TO: Strathfield Local Planning Panel Meeting - 10 April 2025

REPORT: SLPP – Report No. 4

SUBJECT: PLANNING PROPOSAL - NOS 94-98 (LOT 100 DP 862635) COSGROVE ROAD, STRATHFIELD SOUTH

DA NO. PP 2024.2

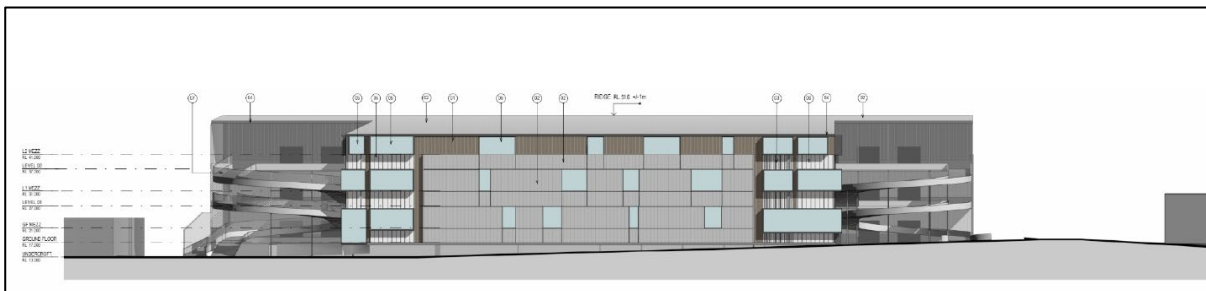
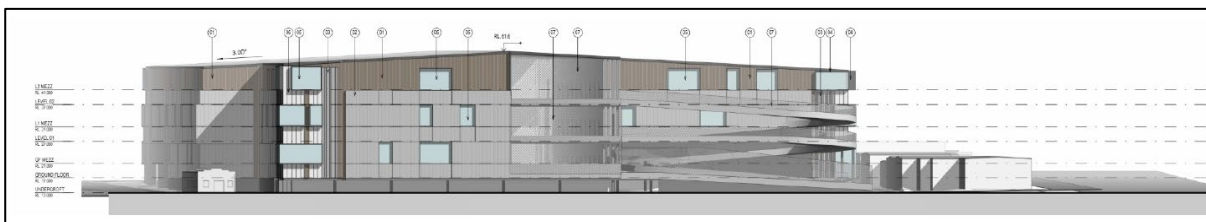
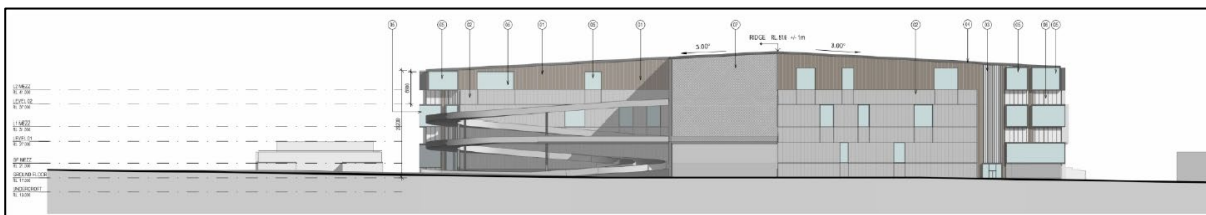
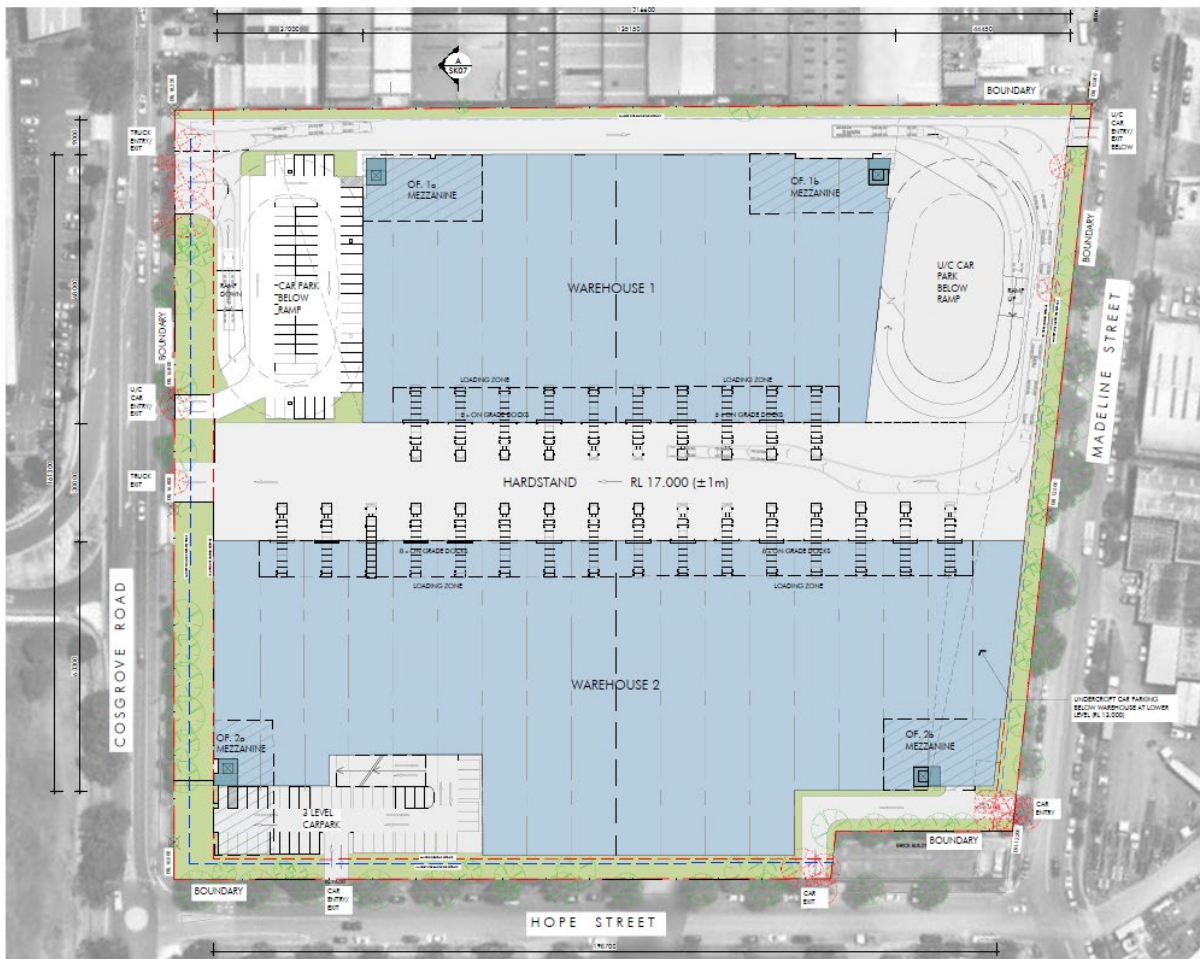
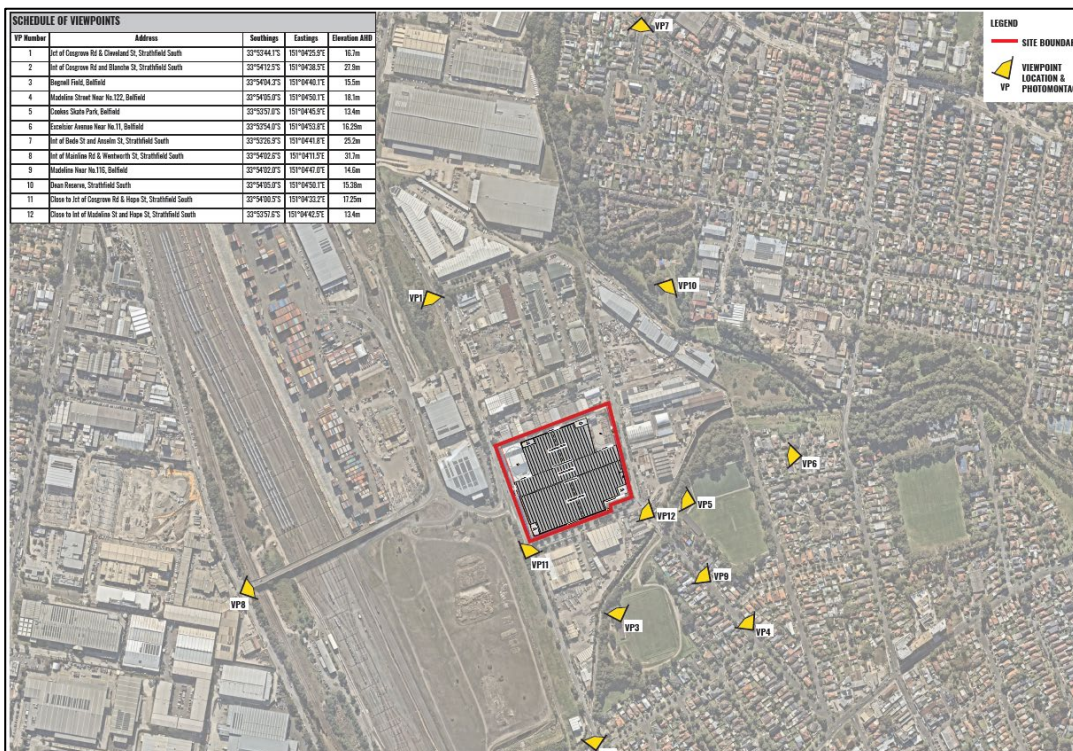
A 35m high building, which would be comparable in height to a 10-storey residential flat building, and with no transition in height, would have a significant visual impact for the low-density residential areas to the south (maximum height of 9.5m), as well as open space areas located along Cox's Creek and the Cookes River.

The draft Planning Proposal seeks to amend the maximum HOB from 12m to 35m metres to facilitate the redevelopment of the site for a three (3) storey industrial and warehouse building. This represents a 191.6% increase to the existing height under the Strathfield LEP. A 35m tall building is equivalent to a 9-10 storey residential flat building, which exceeds the height of any built form in the locality.

During the assessment of the Planning Proposal, Council informed the Proponent that a maximum height of 25m could be supported. This height would facilitate appropriate transitions between the site and the residential areas to the south, while allowing the building to be at or slightly above the existing and future canopy tree heights. However, the Proponent has stated that a 25m height limit does not align with their future vision for the site.

**Figure 27 – Southern Elevation**

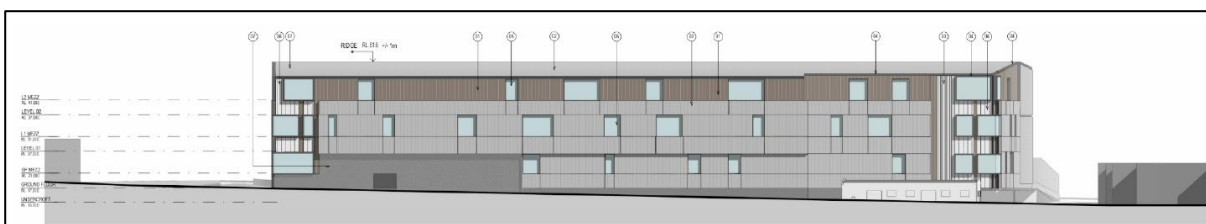
The proposal's longitudinal (east-west) dimension is 208.1m, resulting in a very large southern façade orientated towards residential areas and public open spaces. Noting the need for large floor plates and stacking heights, physical articulation (via through breaks in the building and/or separation of the building and upper-level setbacks) would be difficult to achieve. When combined with the proposed height, any future building on this site, which will have long and expansive facades, will be significantly intrusive, particularly when viewed from the residential and open space areas.

However, the images show small portions of a building that will have a 200m long southern façade and similar length along the eastern façade. The viewpoints show a narrow view window that indicates the visual impact of the building will be mitigated by trees and buildings in the foreground. This is considered to underplay the presence of the building in the local environment, which currently features a 12-15m height plane across industrial areas and 9.5m (at the highest) plane across residential areas.

Council, in discussions with the Proponent advised that the proposed 35m height could not be supported and suggested that a maximum 25m height would be more appropriate in this location. This would allow for more appropriate height transition between the site and residential areas to the south and would result in a building that was less visually intrusive and closer in height to a mature canopy tree.

**Figure 37 – Concept design access at ground floor**

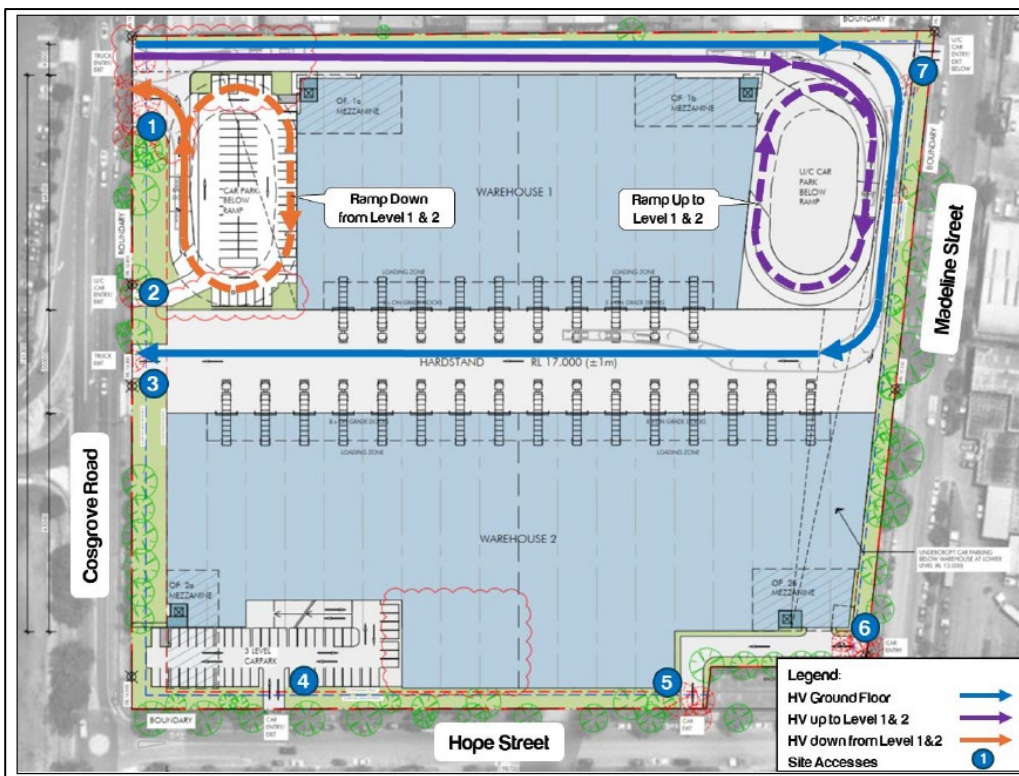
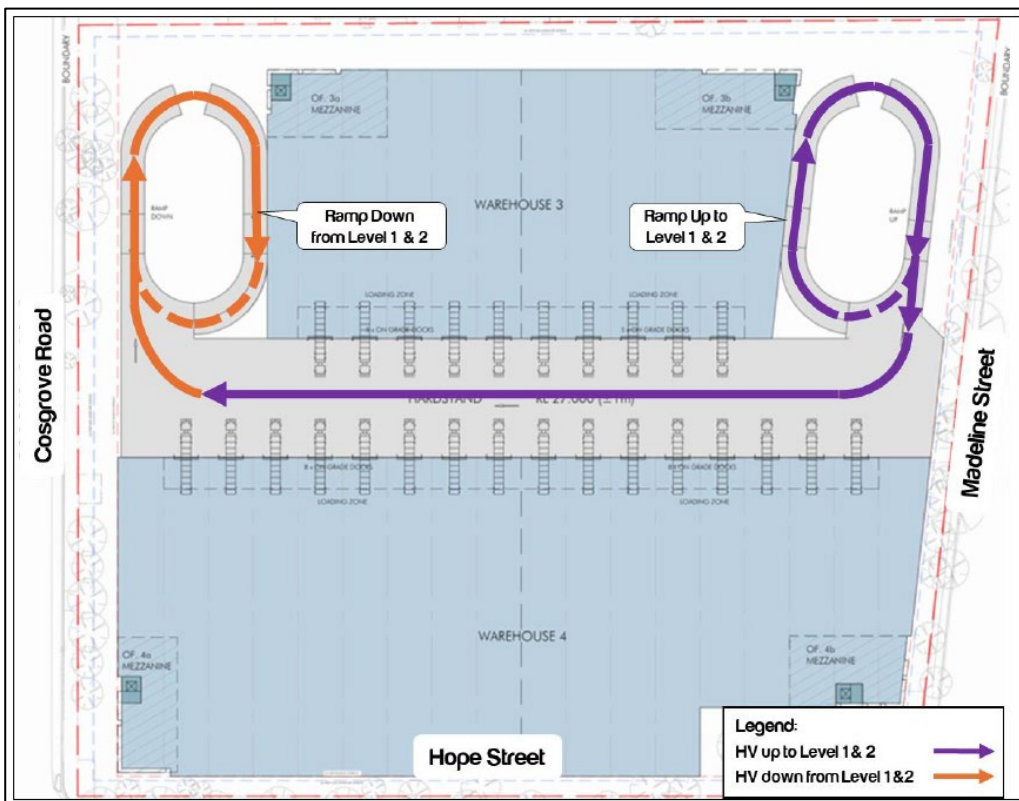
Council's Traffic Engineer reviewed the Planning Proposal documents and was satisfied, subject to detailed design at the development application stage, that the LEP amendments allow for suitable vehicle access, heavy vehicle routes, on-site parking provisions, car parking layout and geometric and traffic generation.
